# ADDENDUM NO. 3

**February 4, 2022**

**Carmel High School Natatorium  
520 Est Main Street  
Carmel, IN, 46032**

This Addendum consists of Pages ADD 3-1 through ADD 3-4, and attached drawing sheet A8S.01 for scope clarification on concrete responsibility break between Bid Category #1 and Bid Category #11

# S3.05

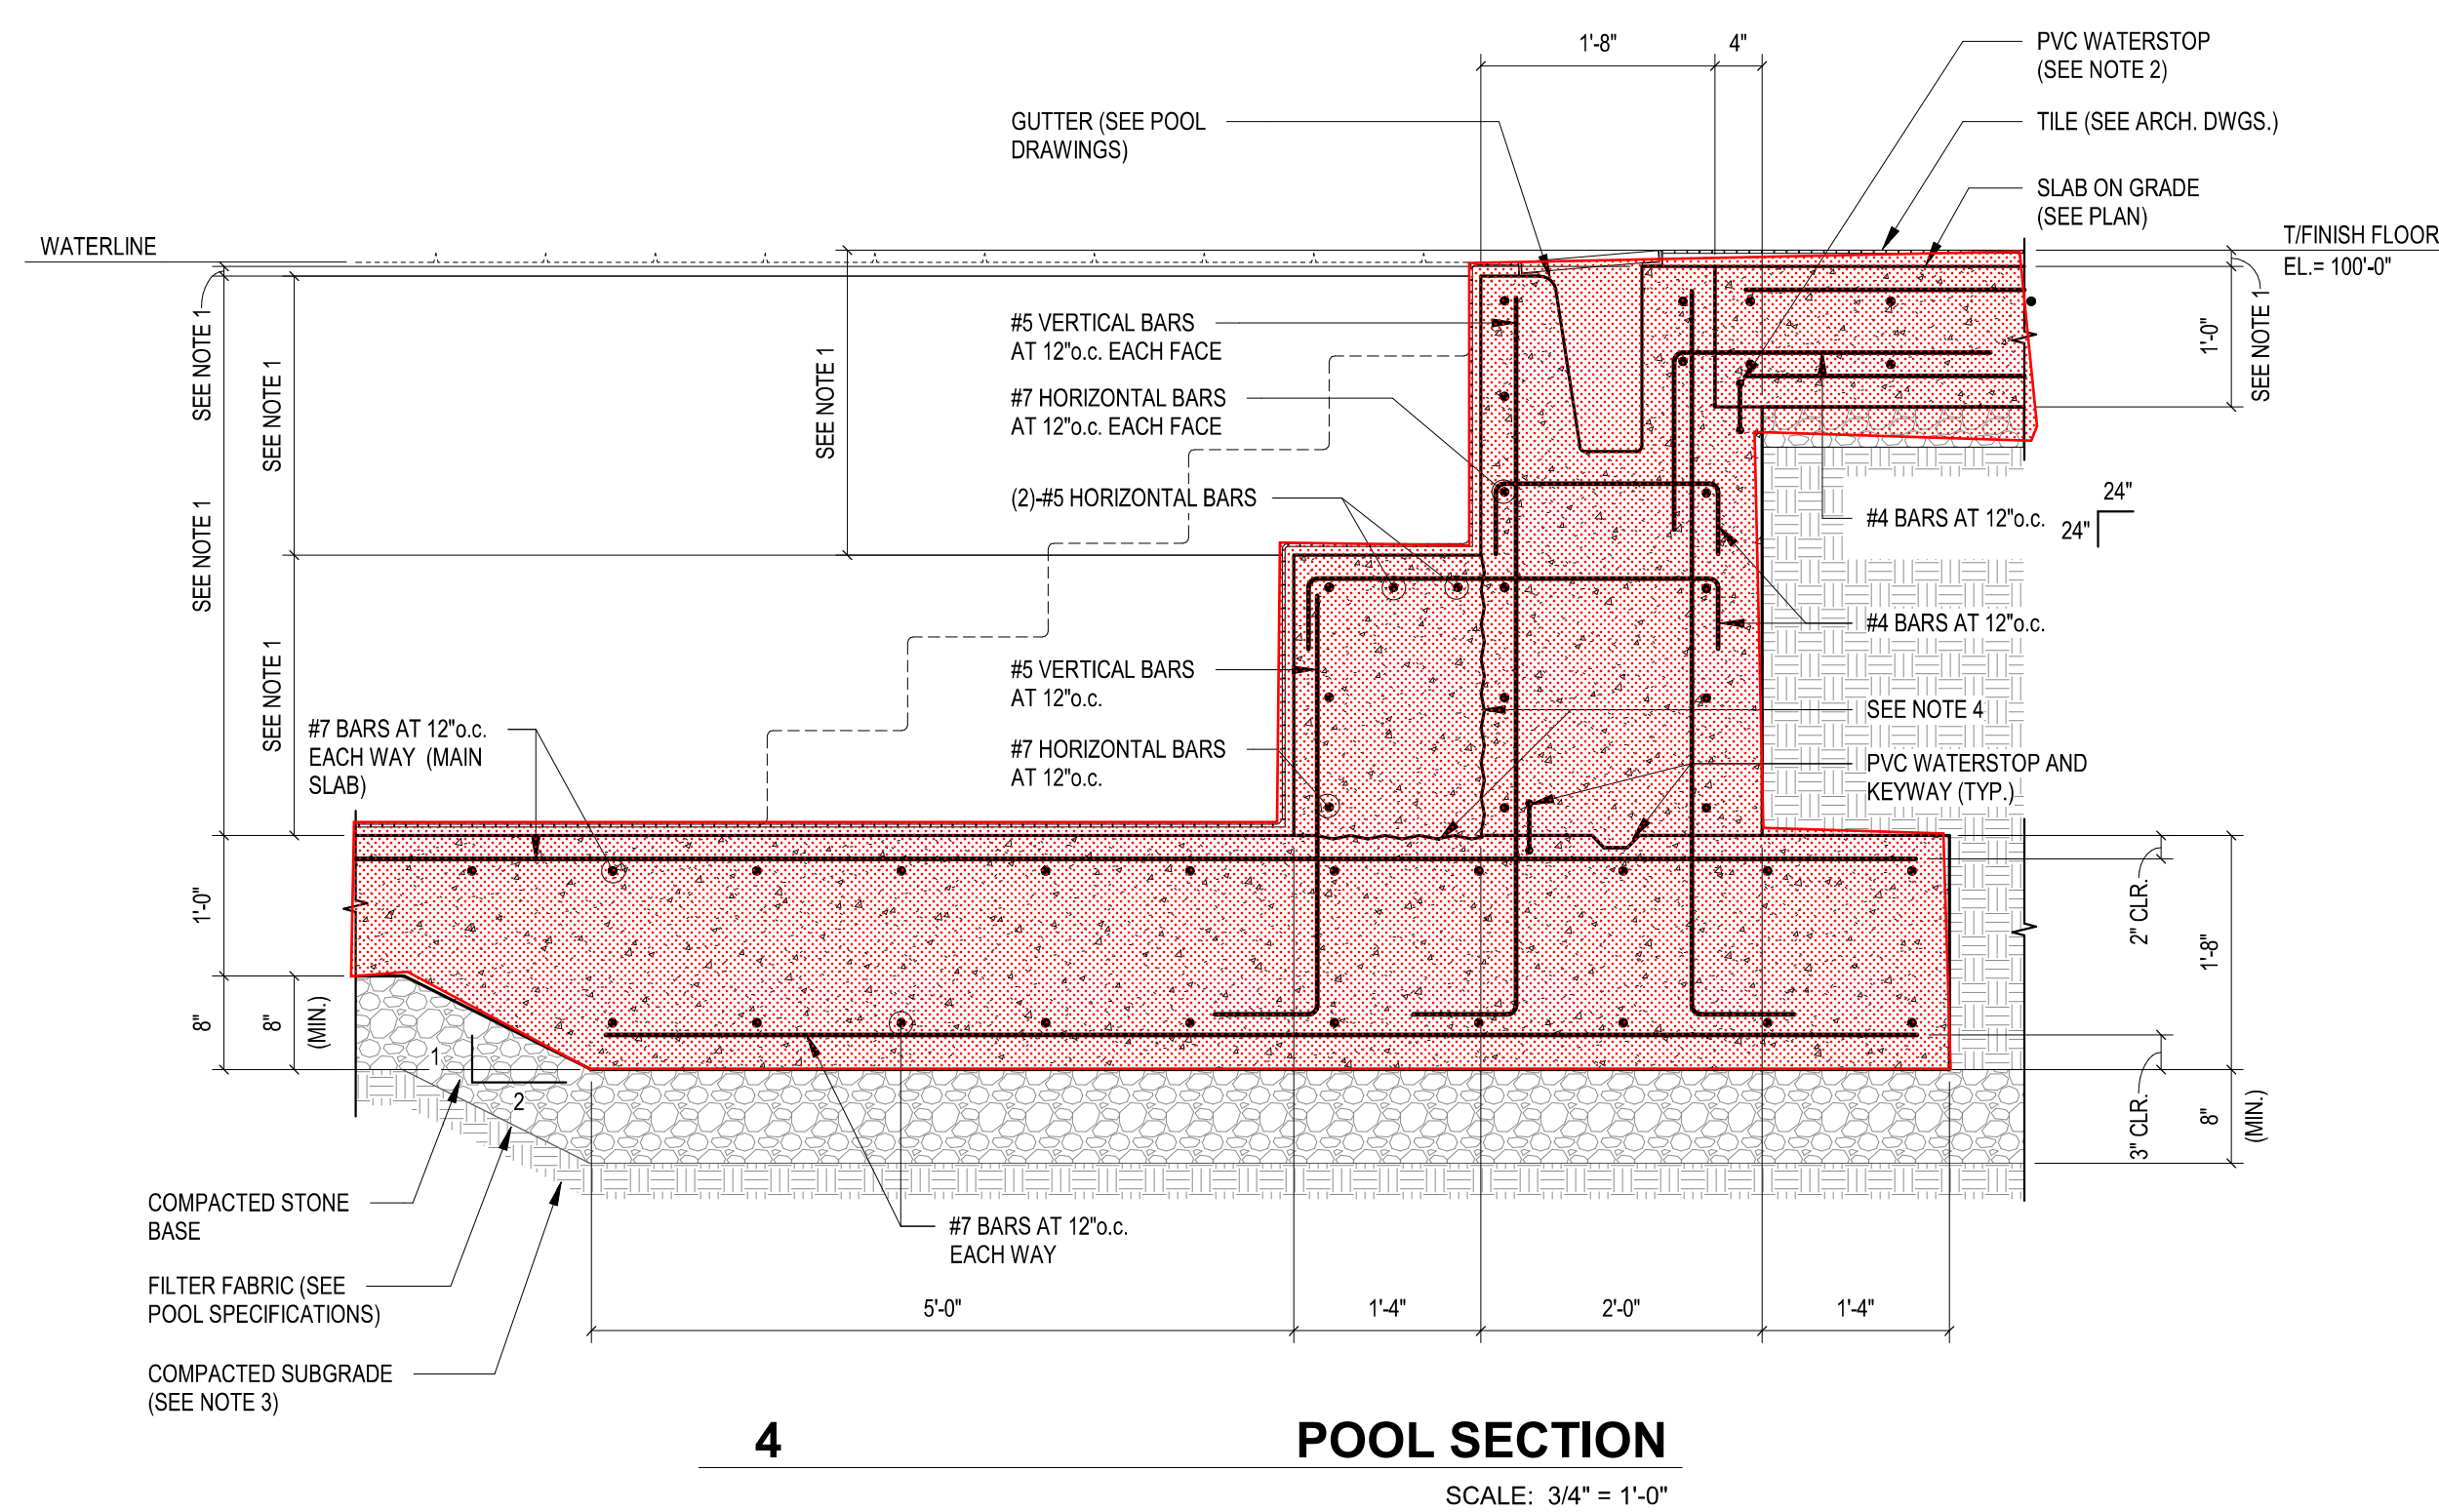
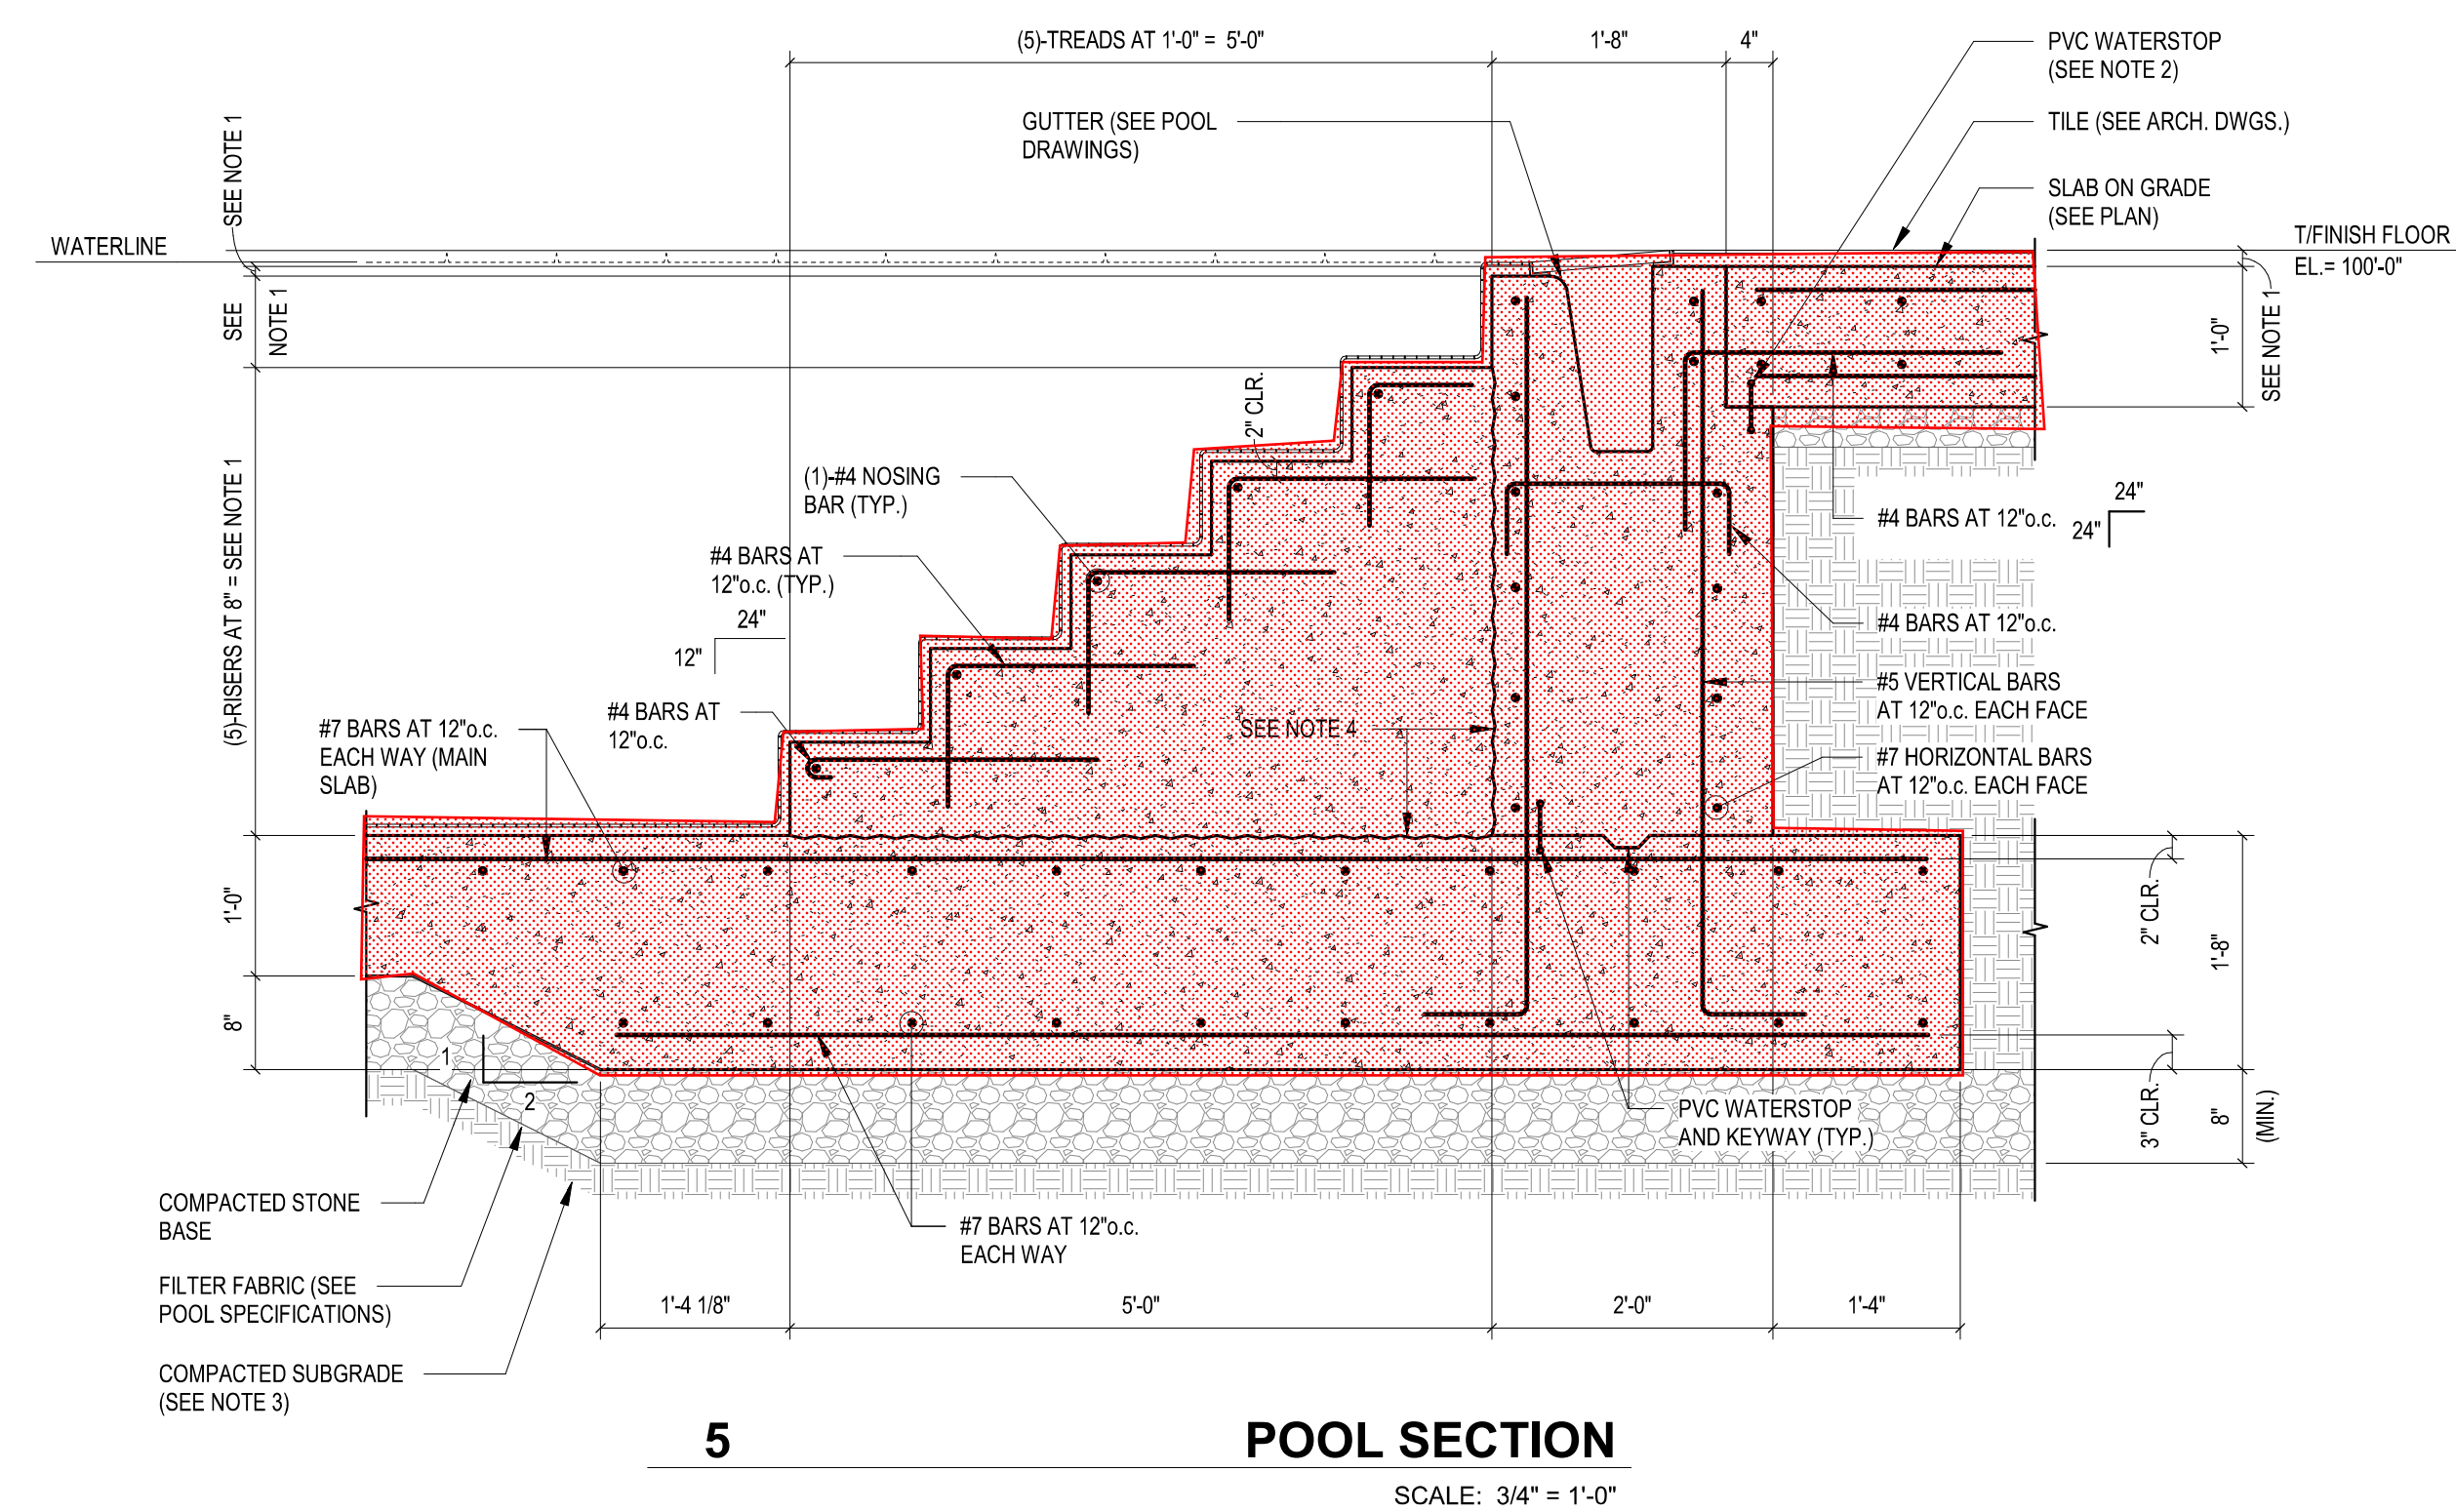
See attached sheet S3.05 Shaded to further clarify the Bid Category 11 Concrete responsibility including the pool base, sides, and deck as shown in the section view attached.

See attached sheet S3.05 Shaded to further clarify the Bid Category 11 Concrete responsibility including the pool base, sides, and deck as shown in the section view attached.

**ADDENDUM #01 (01/25/2022) CLARIFICATION:**  
**POOL SECTION NOTES:** Add "COORDINATE OVERALL CONCRETE DIMENSIONS WITH THE TILE FINISH AND SETTING BED TO ENSURE CORRECT FINISHED FACE OF TILE DIMENSIONS" to Note 1.
